CITY OF HOBART

## **City Planning Committee Meeting**

### 7.1.3 54 KING STREET, SANDY BAY - PARTIAL DEMOLITION, ALTERATIONS, EXTENSION, PARTIAL CHANGE OF USE TO SHOP, AND SIGNAGE PLN-16-1235 - FILE REF: F17/13931

**APPLICATION UNDER HOBART INTERIM PLANNING SCHEME 2015**

elevation NEW south & east DA.04 (C)  
proposed redevelopment for Mr.Kim  
54 King Street, Sandy Bay TAS 7005 160301

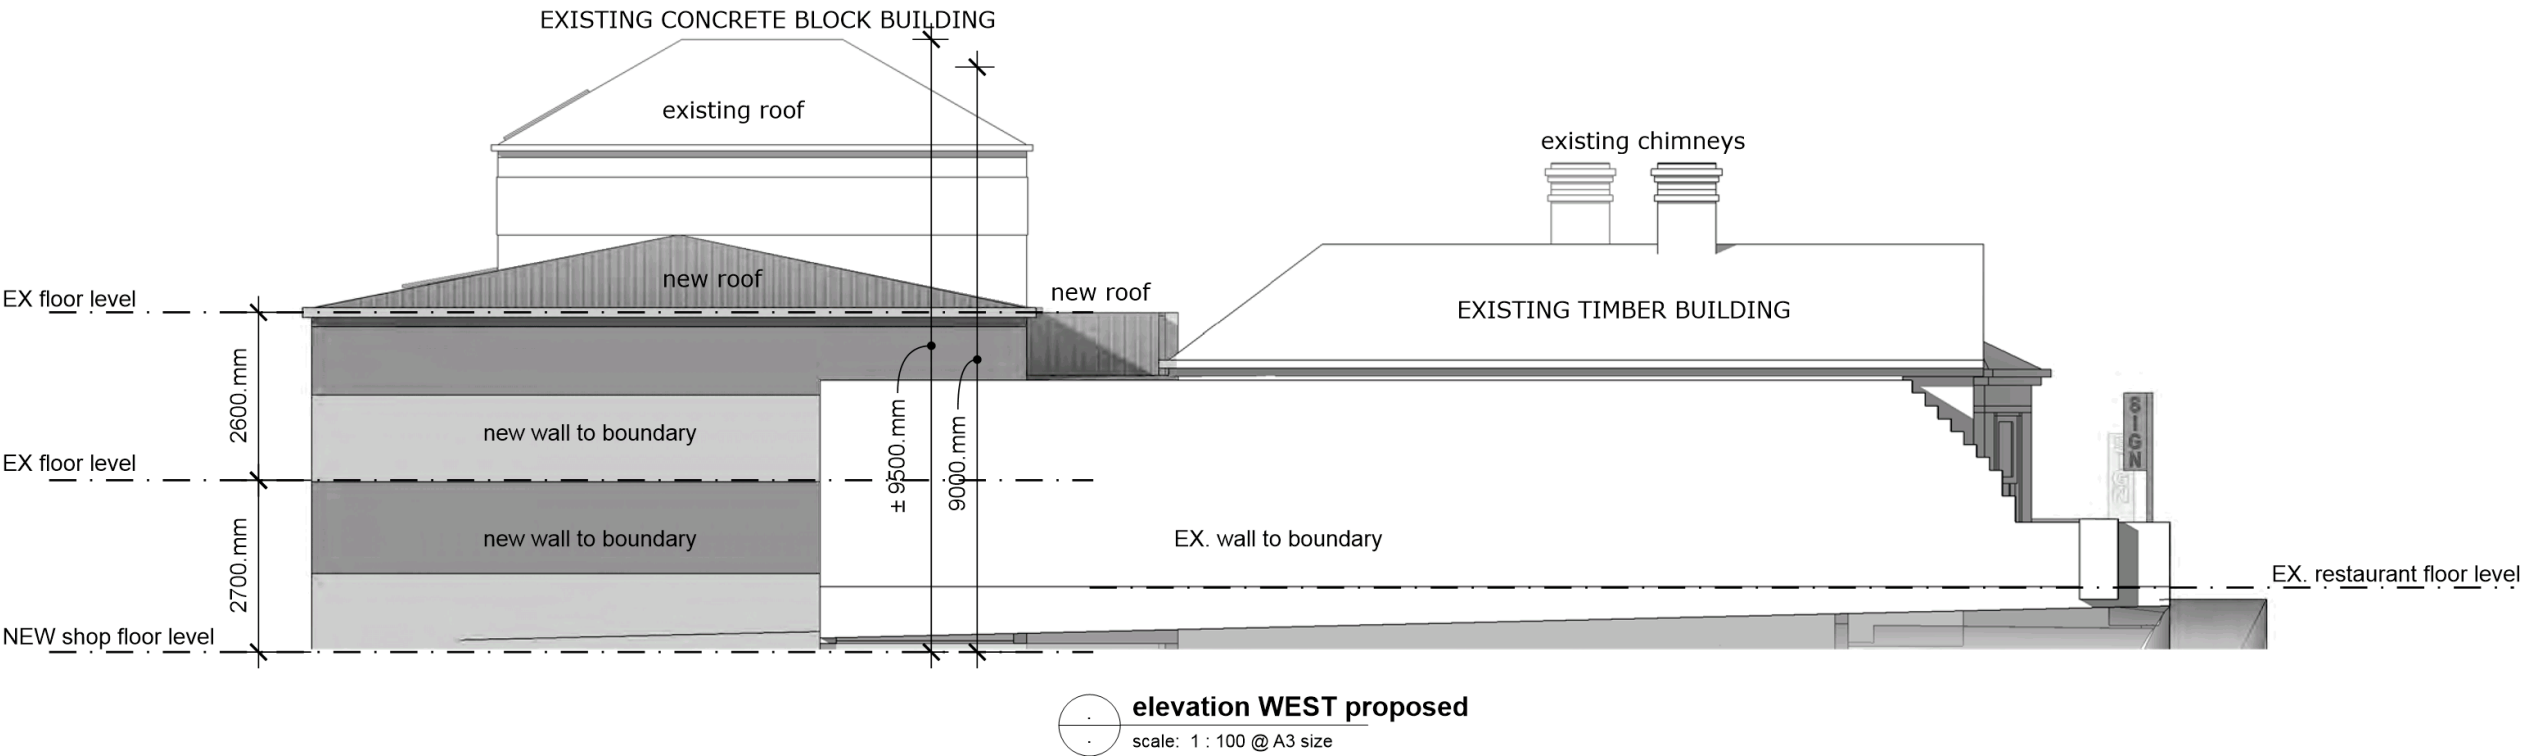
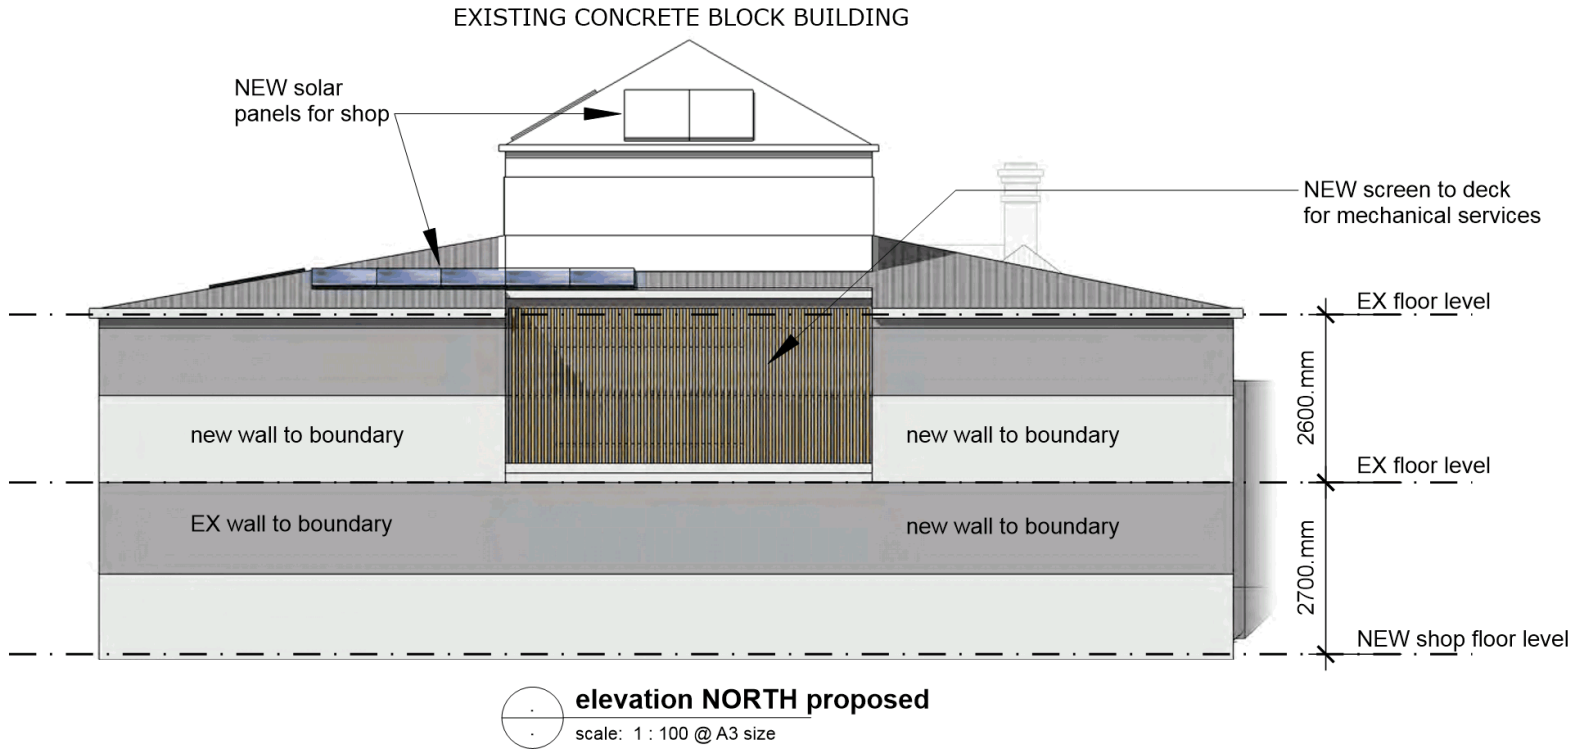
Figure 8. The proposed four frontage signs for 54 King Street (excerpt from submitted plan DA.04(c) dated 28.11.2016). Does not include wall sign on side boundary.

elevation NEW north & west DA.05 (C)  
proposed redevelopment for Mr.Kim  
54 King Street, Sandy Bay TAS 7005 160301

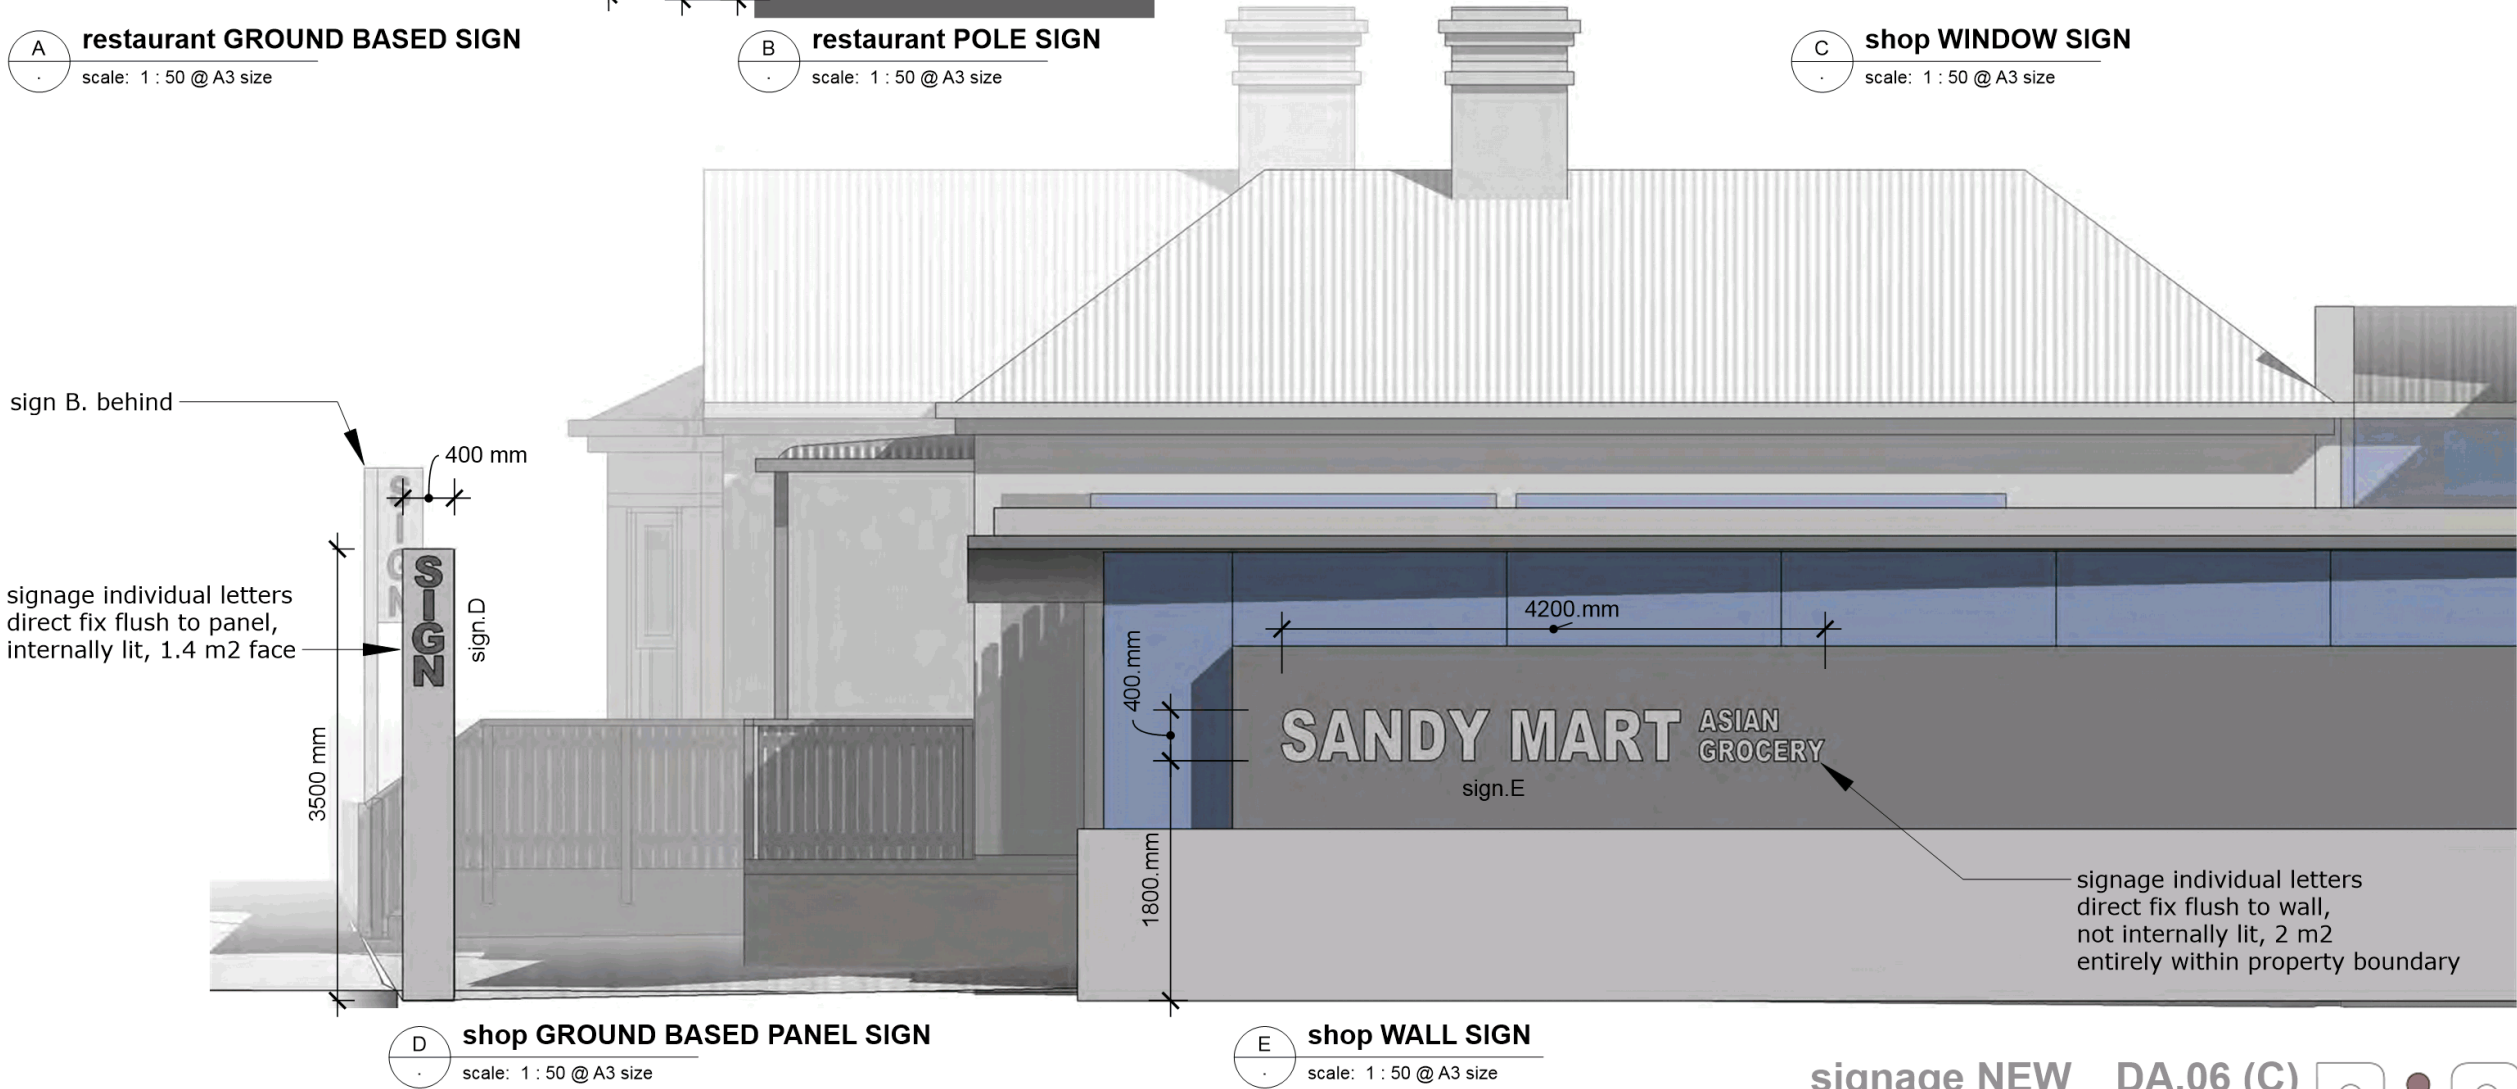
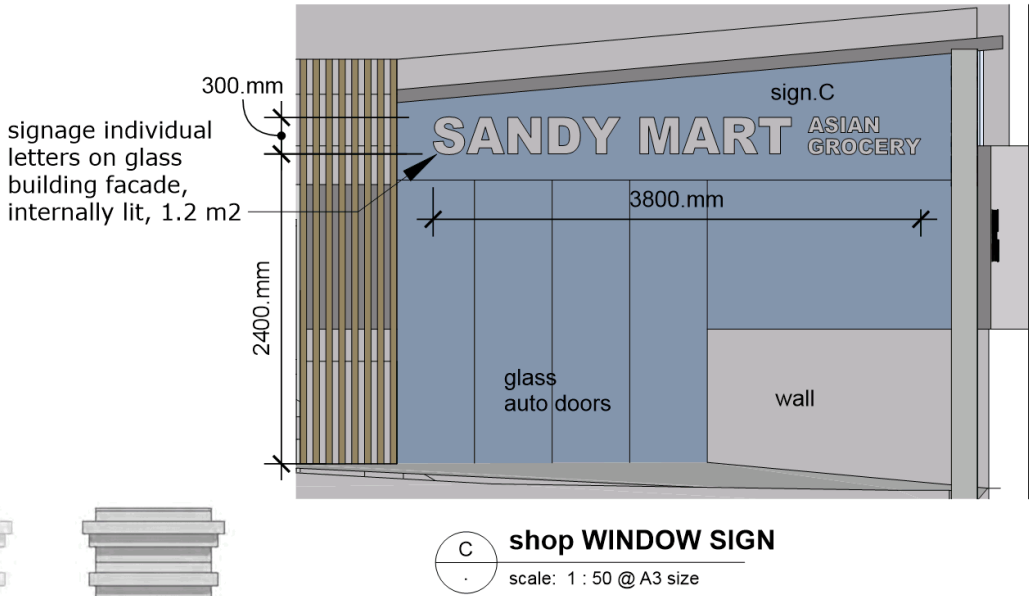
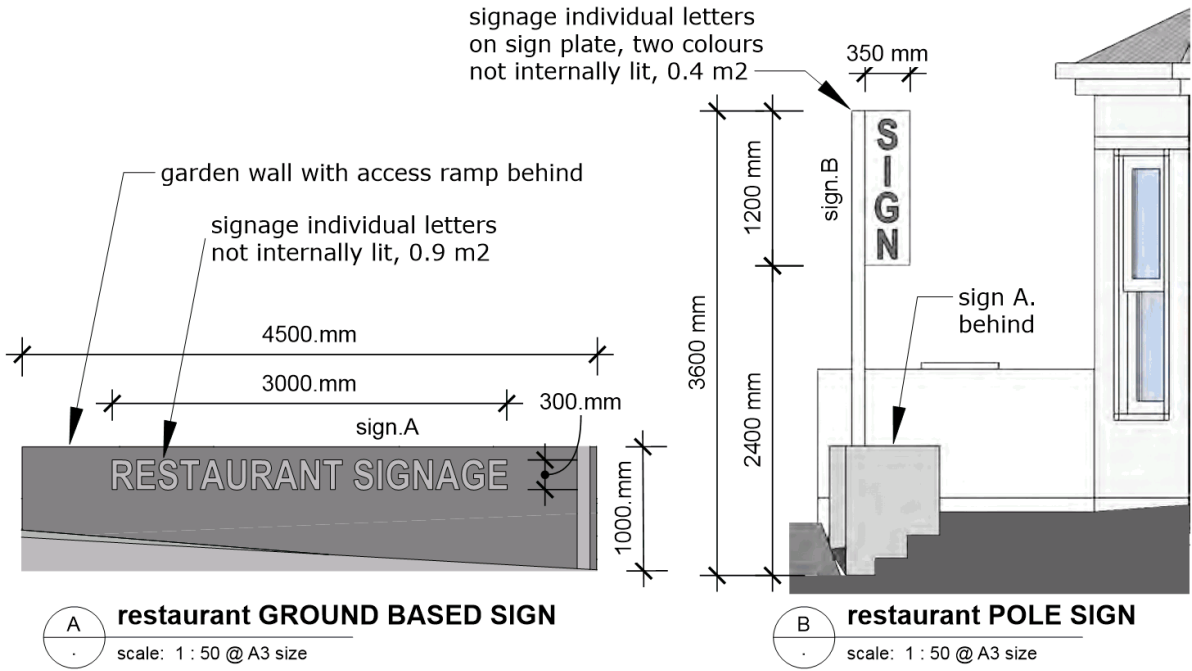
**Plans submitted for building approval must specify the light reflectance value of the western facade in accordance with this requirement.**

**signage NEW DA.06 (C)**  
proposed redevelopment for Mr.Kim  
54 King Street, Sandy Bay TAS 7005 **160301**

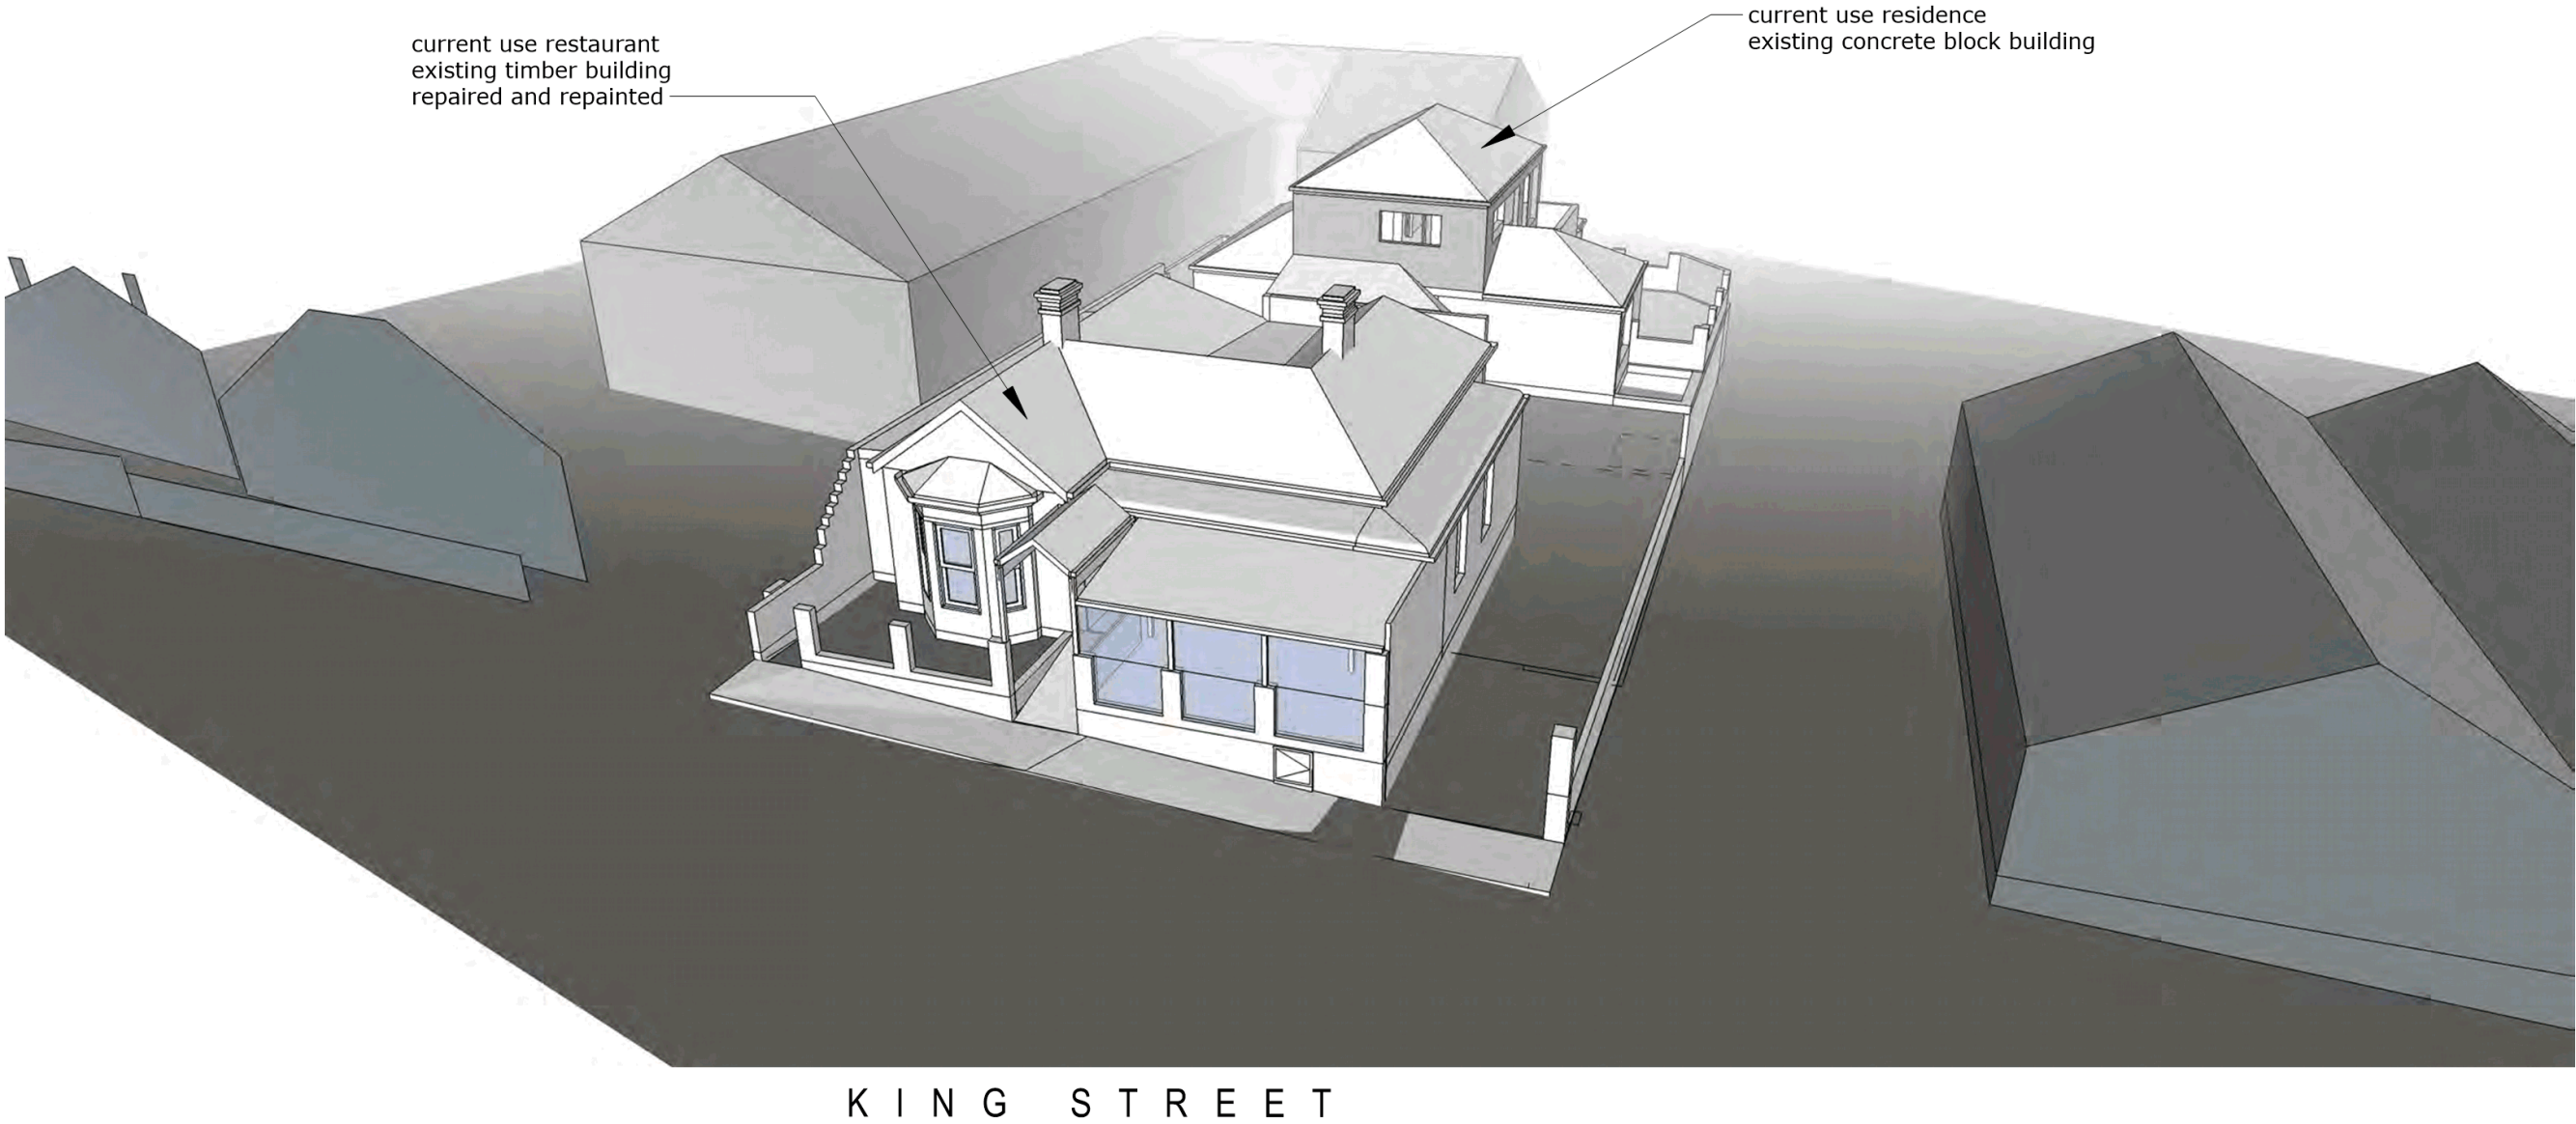
3.4 For sign details see Plan 'signage new' DA.06(c). The proposal includes the following signs (letters as labelled on plans, definitions from Signs Code E17.0):

6.15.5 The four signs as proposed are supported. The proposed side boundary wall sign (labelled E on the plans) is not ideal as it is setback 7 metres from the frontage at its closest edge and would face towards the adjacent lot car park and right of way at 52 King Street. The sign may contribute to conflict with regard to use of the adjacent lot for car parking and deliveries, however there is nothing in this standard relating to a side boundary sign.

**The ground based panel sign (shown as sign D on the submitted plans) must not be flashing or intermittently illuminated.**
